SERVICE BULLETIN

Service Bulletin No.: DA20-33-03 Rev 0

Title: Cockpit Night Lighting System Installation

SUPERSEDES: DA20-33-01

Figure 1:

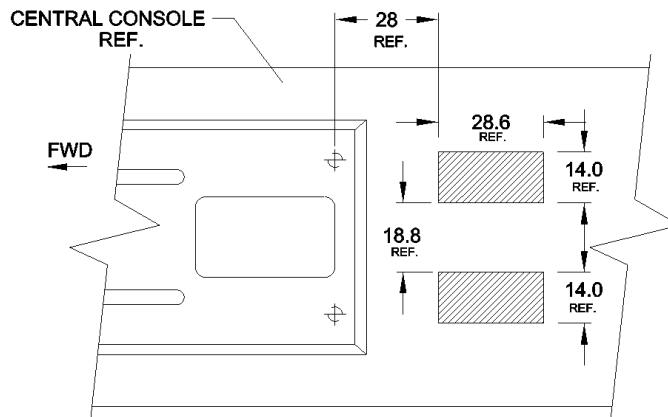
- 10.6 Drill and cut out the mounting holes for the two rocker switches in the center console as shown on Figure 1.

Figure 2:

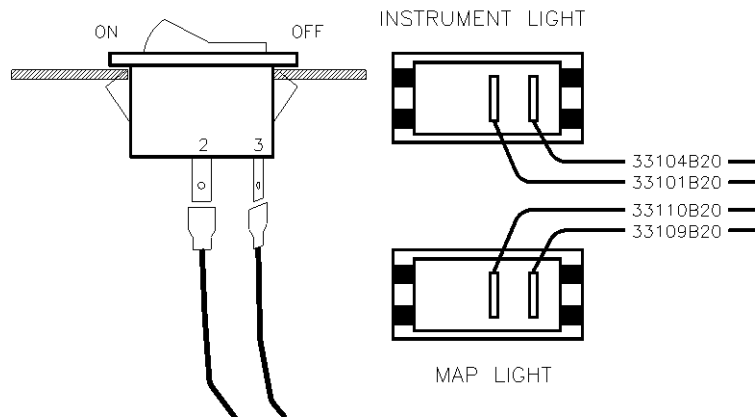
- 10.7 Route the fuselage harness from the rear of the instrument panel down along the existing harness, which runs through the center console on the right side of the fuselage, to the bottom of the spar bridge.
- 10.8 Pass the switch wires through their respective holes and connect them to the switches in accordance with Figure 2.

Figure 3:
(Looking fwd)

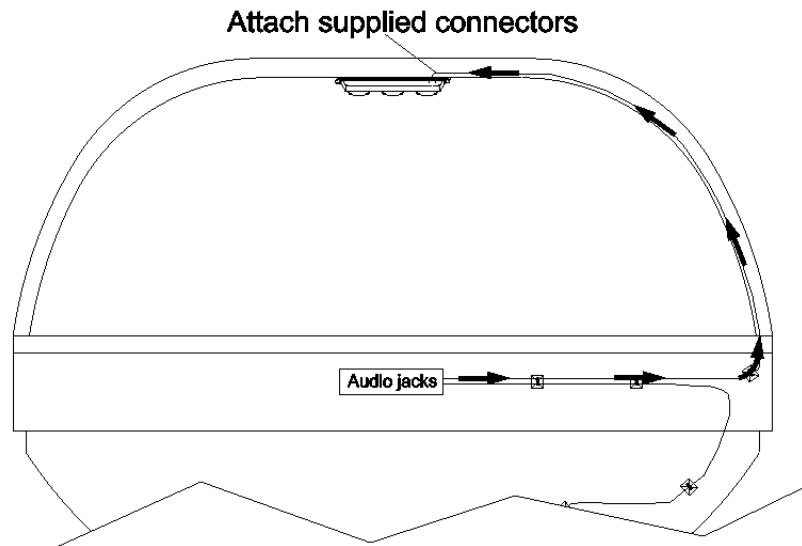
- 10.9 Route lighting wires through existing conduit up to audio jacks, then through new conduit supplied, using a fish wire.
- 10.10 Attach connectors supplied to lighting wires.
- 10.11 Run conduit along RH inside edge of fuselage roll bar lip to top center position. Hold in place with adhesive DP-110 in accordance with Figure 3.

Figure 4a: Trim DIM/BRIGHT Switch
(Looking fwd)

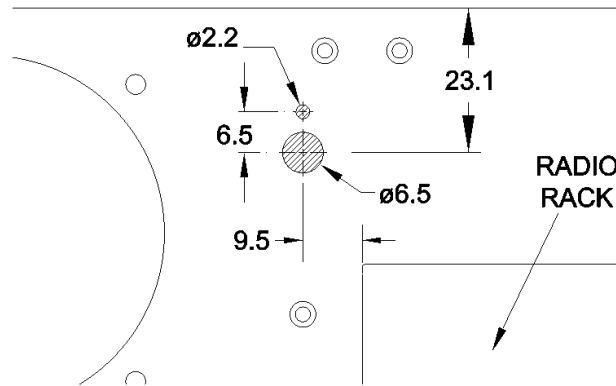
10.14 Remove labels and drill holes in instrument panel for Trim DIM/BRIGHT switch, Dimmer Rheostat and Fuel Valve LED, in accordance with Figures 4a, 4b and 4c.

Note: Trim DIM/BRIGHT hole locations differ for serial numbers.

**Figure 4c: Fuel Valve LED
(Looking down)**

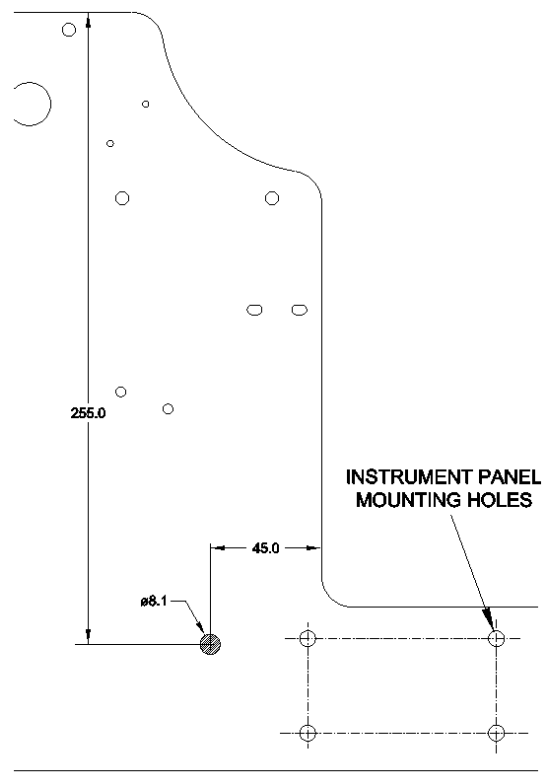
- 10.28 Change internal light breaker from 7.5 amps to 1 amp. Map light power supply is protected by taxi light breaker.
- 10.29 Install LED pigtail assembly into hole cutout in Figure 4c.

Figure 5

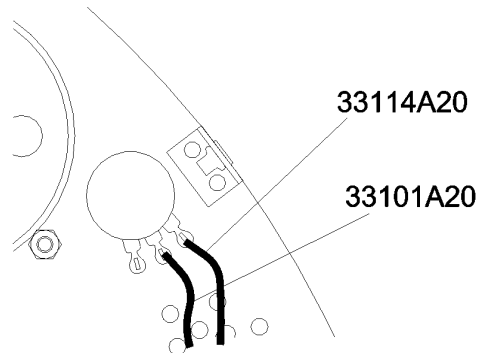
- 10.15** Install and route internal lighting retro-fit harness following existing harness.
- 10.16** Secure 27512A22 wire to Flaps circuit breaker.
- 10.17** Secure 33109A20 wire to TAXI/MAP circuit breaker.
- 10.18** Secure 33104A20 wire to INTERNAL LIGHT circuit breaker.
- 10.19** Secure 33111A20N, 33108A20N and 33113A20N to ground terminal block TB2400-03.
- 10.20** Replace existing trim indicator with new trim indicator.
- 10.21** Solder Dimmer Rheostat as shown in Figure 5.

Figure 6

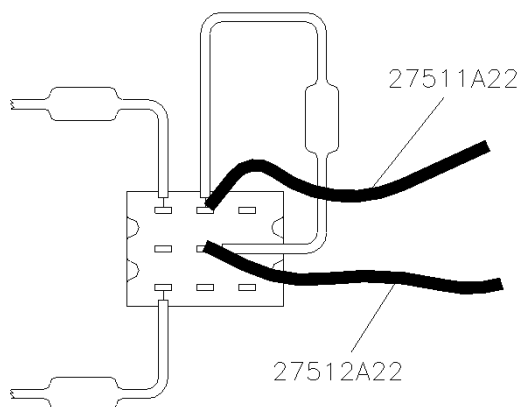
- 10.22** Continue with operation if flap switch controller is S/N 200 or above. If flap switch is S/N 199 or below, replace with new flap switch controller before continuing.
- 10.23** Remove flap position label to expose potentiometer adjustment and turn fully clockwise. Replace label.
- 10.24** Remove the flap controller connector P2750-01. Remove pin 'M' and cut the jumper wire that goes to pin 'H' close to the pin. Reinsert pin 'M'.
- 10.25** Remove pin 'H' and discard the pin with the remaining short jumper wire attached.
- 10.26** Insert supplied 27511A22 wire, from retro-fit harness, into pin 'H' of the flap controller.
- 10.27** Solder wires 27511A22 and 27512A22 as shown in Figure 6.
